**STEBENVILLE CITY SCHOOLS
HIGH SCHOOL ENTRY / CLASSROOM RENOVATION****TO: ALL BIDDERS**

END OF ADDENDUM TWO

STUEBENVILLE HIGH SCHOOL STEM BUILDING

PROJECT NO.
21042.000

E3-2

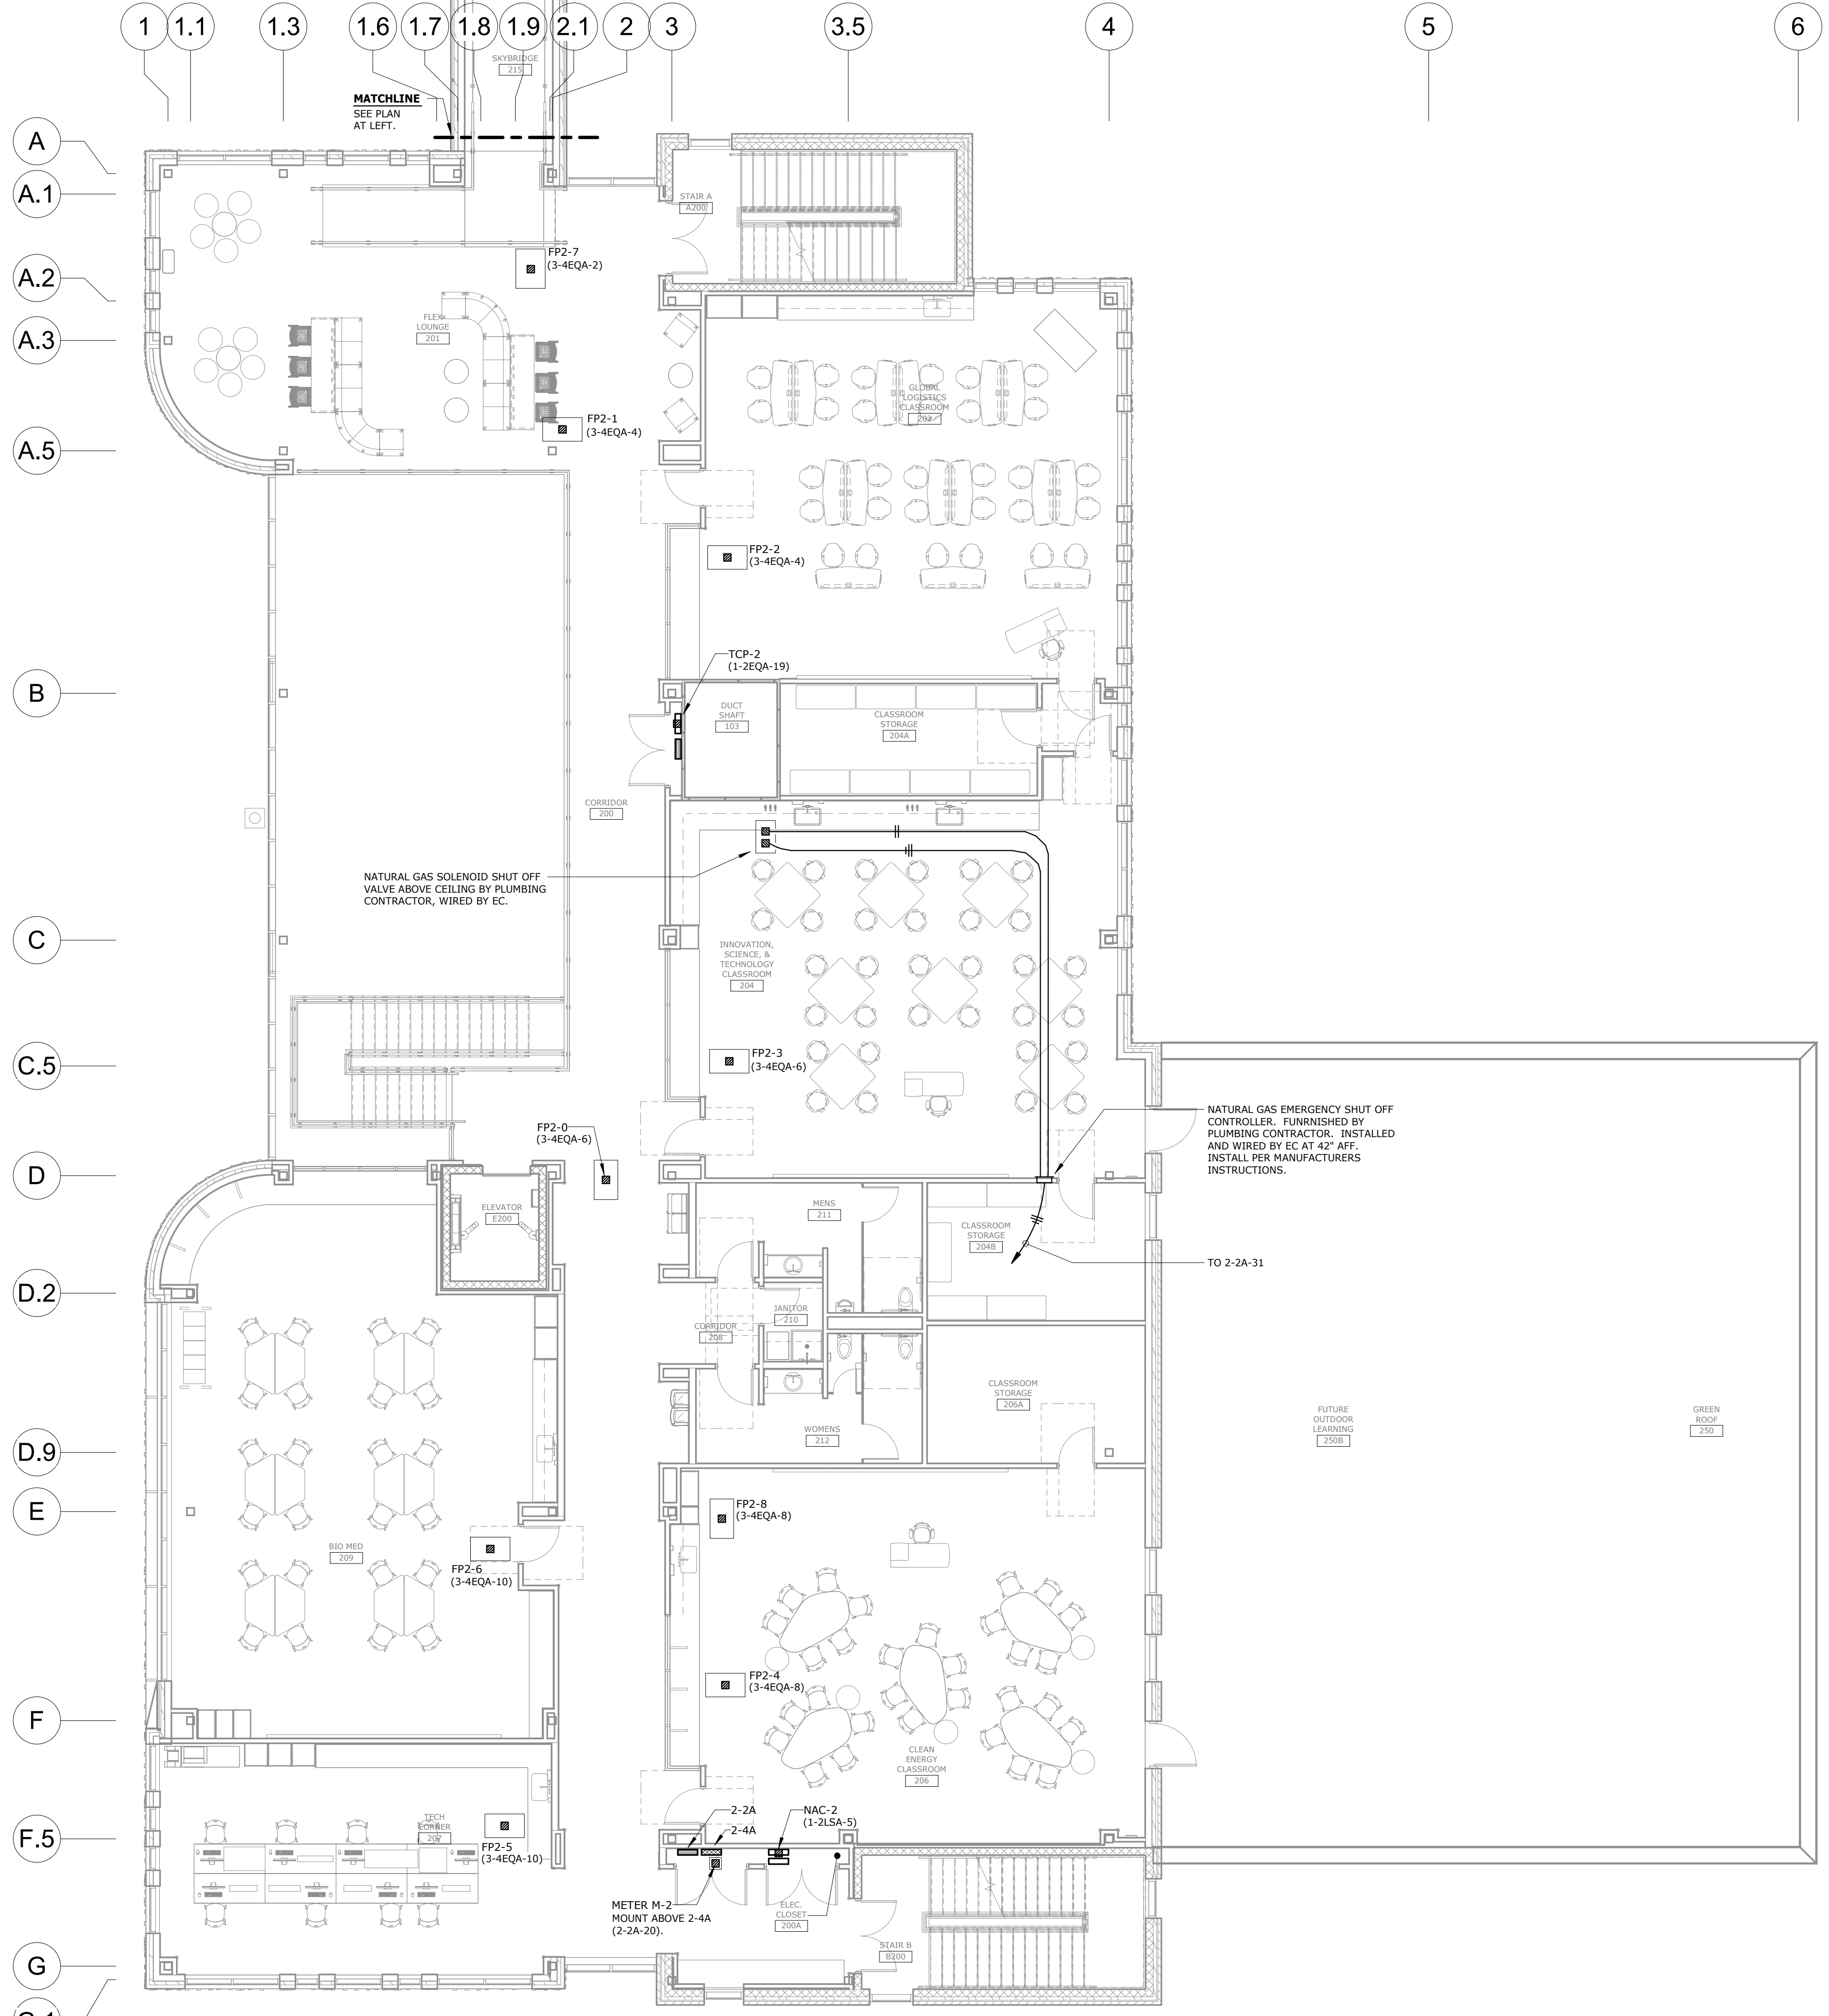
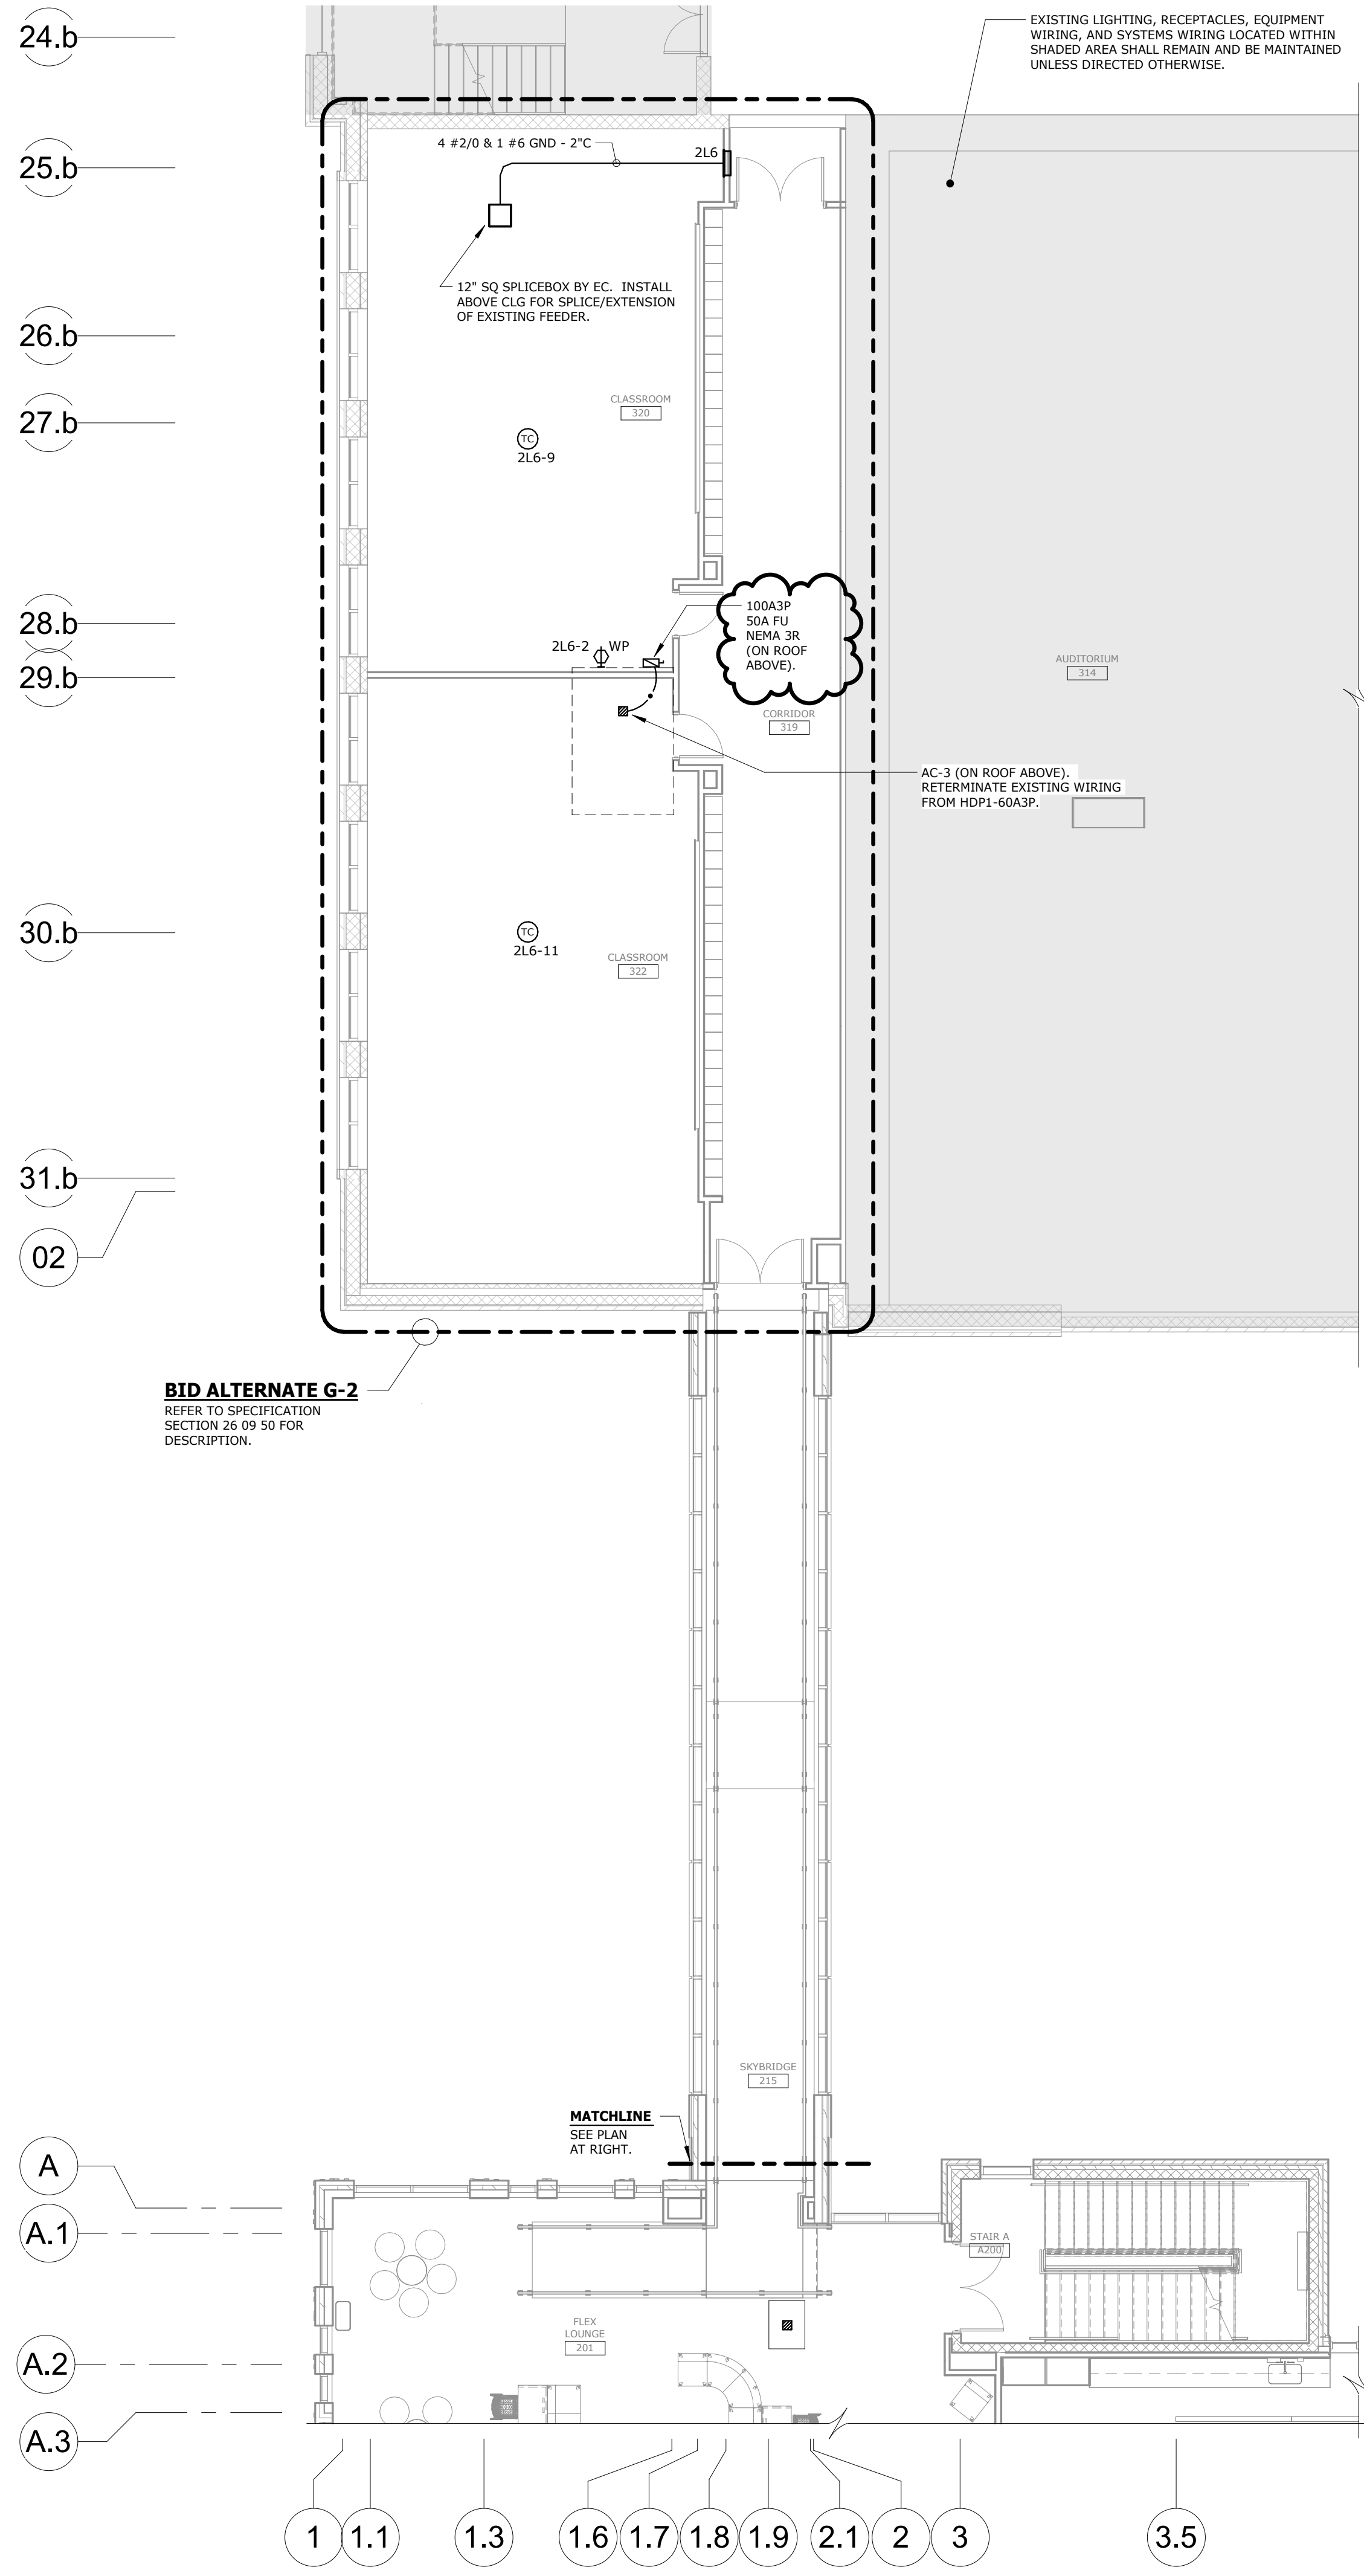
1. Drawing M1-2
 - a. Modified VAV box sizes.
 - b. Added transfer air opening.
 - c. Added return boots to return grilles.
 - d. Add acoustical lining to SA / RA off RTU.
 - e. Added elbow to corridor return.
 - f. Modified duct routing and sizes
2. Drawing M5-6
 - a. Updated VAV box schedule
 - b. Updated RTU schedule
3. Drawing E3-2
 - a. Modified disconnect fuse size.
